To: Randy Hill, Public Works Director  
FROM: Jon Lutz, City Engineer  
DATE: March 18, 2014  
RE: Change Order 1 – Colorado Street Project

Change Order

**Colorado Street Re-Construction**  
**Park Avenue to University Drive**  
**IDOT Project No: STP-U-5330(616)-70-70**  
**SHPE No. 13381/10015**

**Title: Revised Water Connections at Park Ave.**  
**Date: February 21, 2014**

**COLORADO / PARK 12" TO 8" CONNECTION**

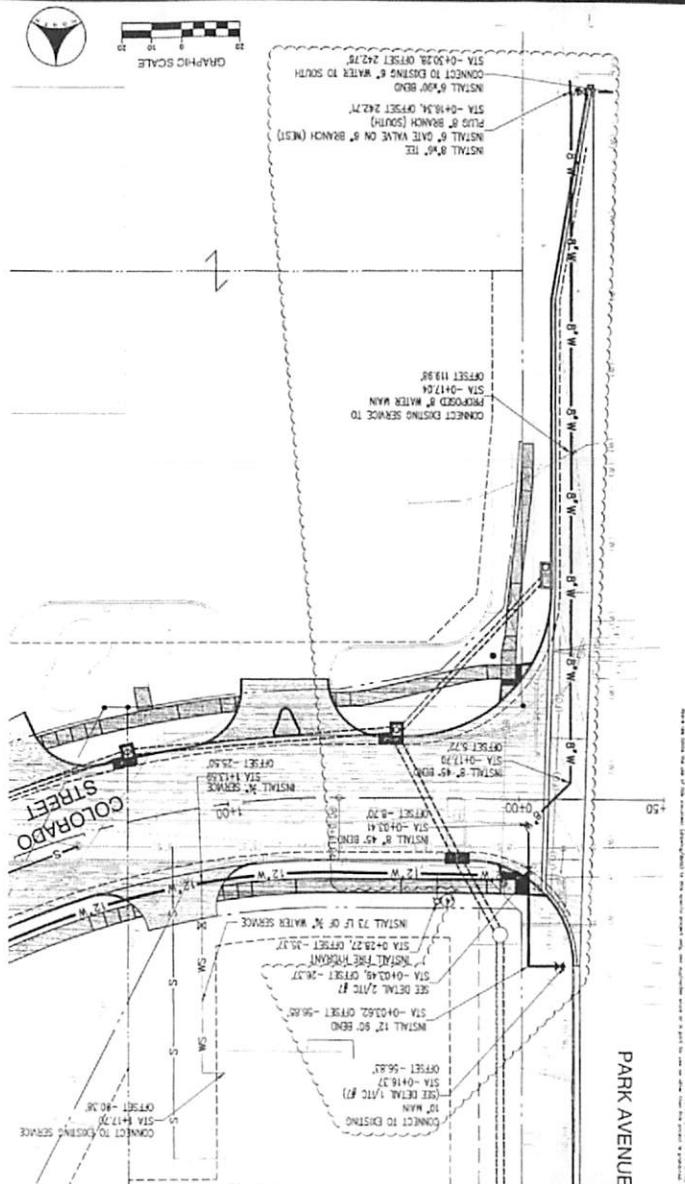
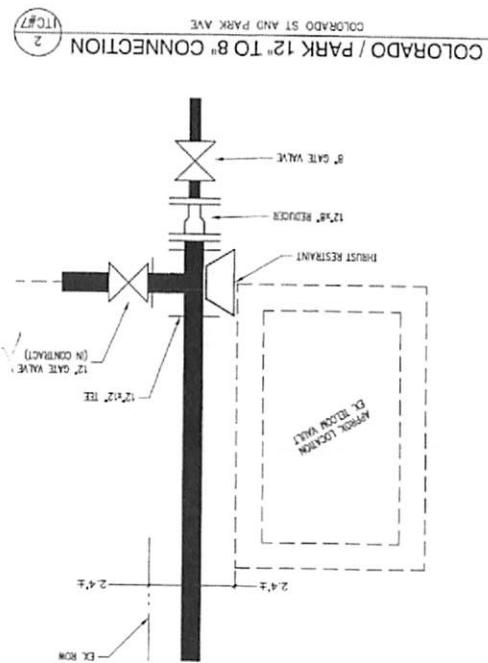
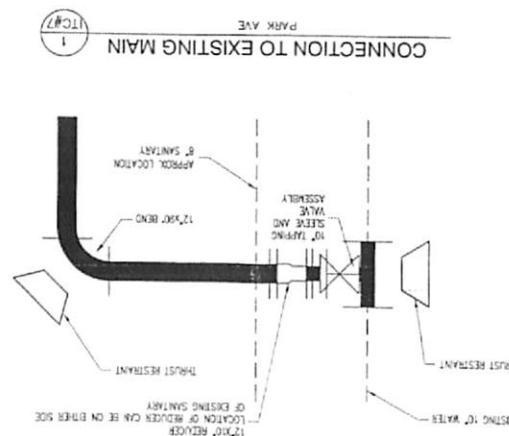
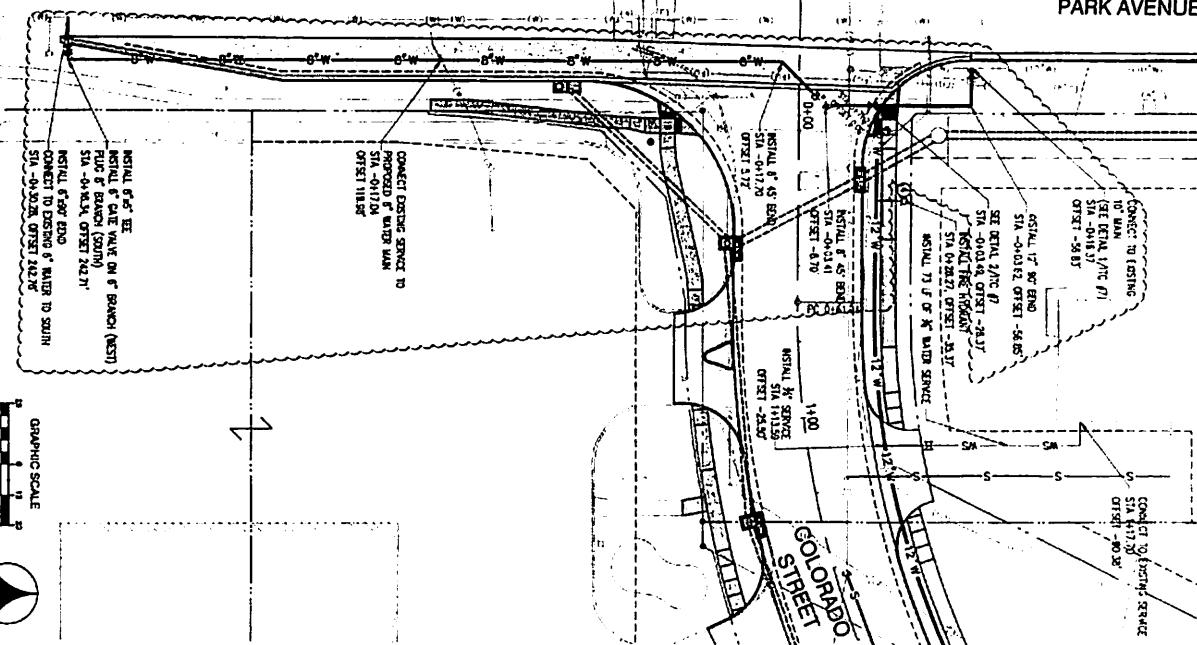
THRUST RESTRAINT  
SHALL BE ADDED  
BY USE OF RESTRAINT ANCHORS DUE TO  
PROBLEMS OF DESTROYING FILTER VALVE

Revise water connections at Park Avenue as shown on ITC #7.

Connect to existing 10" water main in Park Avenue approximately 57 - feet north of Colorado Street centerline with tapping sleeve and valve. Rotate 90 - degrees bend and install additional 45 - degree bends as needed to route proposed 12 - main beneath existing sanitary sewer.

Connect to existing 6" water main in Park Avenue approximately 245 - feet south of Colorado Street centerline. Connect existing 1.5 - inch service to proposed 8 - inch main.

Abandon existing 6" water main north of proposed 8" connection per Owner's standards abandonment of existing utility procedures.
